MEMORANDUM

REVIEW TYPE: Preliminary Plan of Subdivision

PROJECT NAME: Harry Martin Tract

CASE #: 120090040

Figure 2: Preliminary Plan

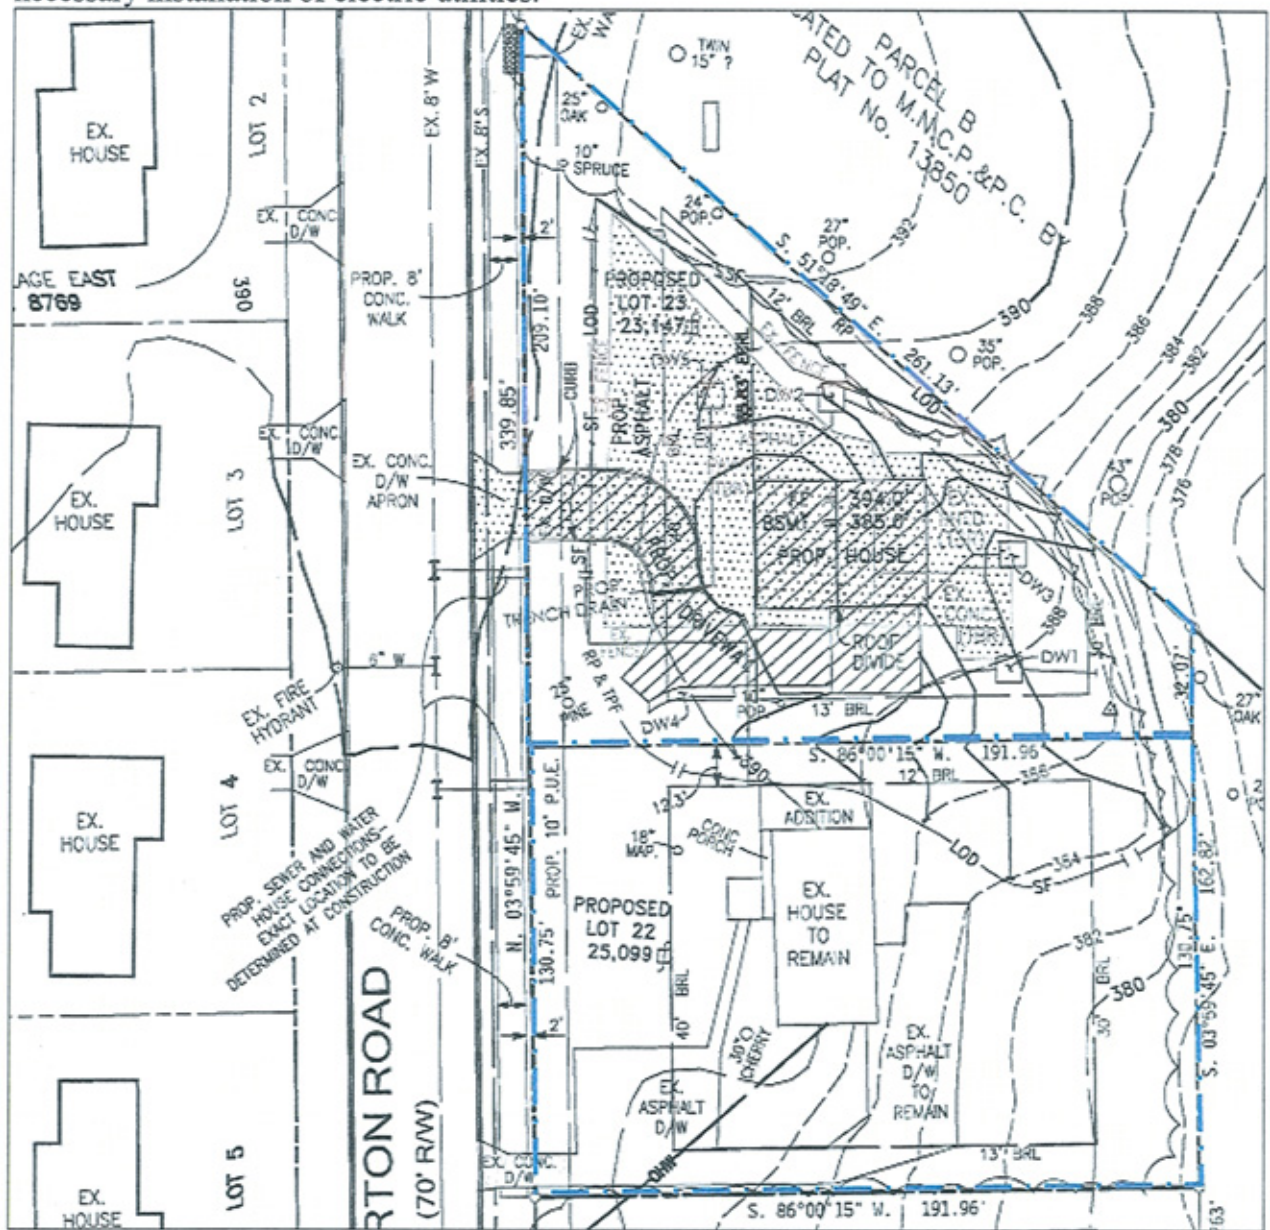
The Applicant proposes to create and record 2 lots from this recorded part of a lot, which constitutes a resubdivision. The proposed plan is depicted in Figure 2 on the following page. Proposed lot 22 is 25,099 square feet in size and proposed lot 23 is 23,147 square feet in size. The existing house is proposed to remain on Lot 22, and houses on both lots will have private driveway access from Alderton Road. A shared use path is required to be constructed along the

Frontage: Lot frontages in the Neighborhood range from 101 feet to 191 feet. Proposed lot 22 will have 130 feet of frontage while proposed lot 23 will have 209 feet of frontage. Resubdivision of the existing lot creates new lots that are closer in conformance with existing lots in the Neighborhood. While lot 23 will have the largest frontage in the Neighborhood, this is unavoidable given the existing property shape. In Staff's opinion, the extra frontage of Lot 23 does not prevent it from being in character with other lots because the area is not usable for a structure given the setback limitations on this rather irregular and triangularly shaped lot. **As a result, the proposed lots will be of the same character as existing lots in the neighborhood with respect to lot frontage.**

Alignment: Of the 7 lots in the Neighborhood, 3 lots are perpendicular in terms of alignment, 2 lots have an angular relationship to the street and 2 lots are corner lots. Proposed lot 22 is perpendicular in its alignment to the street. Proposed lot 23 will have a perpendicular alignment as well, but the northern property line also creates an angular relationship to the street due to the unusual shape of the lot. **Nevertheless, both proposed lots will be of the same character as existing lots with respect to the alignment criterion.**

Shape: Four lots in the Neighborhood are irregular and 3 lots are rectangular lots with respect to shape. Proposed lot 22 is rectangular in shape. Proposed lot 22 has an irregular shape which is mostly triangular, unlike other lots in the Neighborhood. But because lot 22 abuts the MNCPPC Northwest Branch Park along its angled northern lot line, there will be no adjacent development and the lot's shape will not be apparent. As viewed from the street, the lot shape will be in character with others in the neighborhood. **For these reasons, the shapes of the proposed lots will be in character with shapes of the existing lots.**

- 4) The Applicant must construct an 8-foot wide shared-use path (SP-40) off-set two feet from the property line along the property frontage of Alderton Road and connect it to the existing sidewalk that currently terminates at the northwest corner of the property.
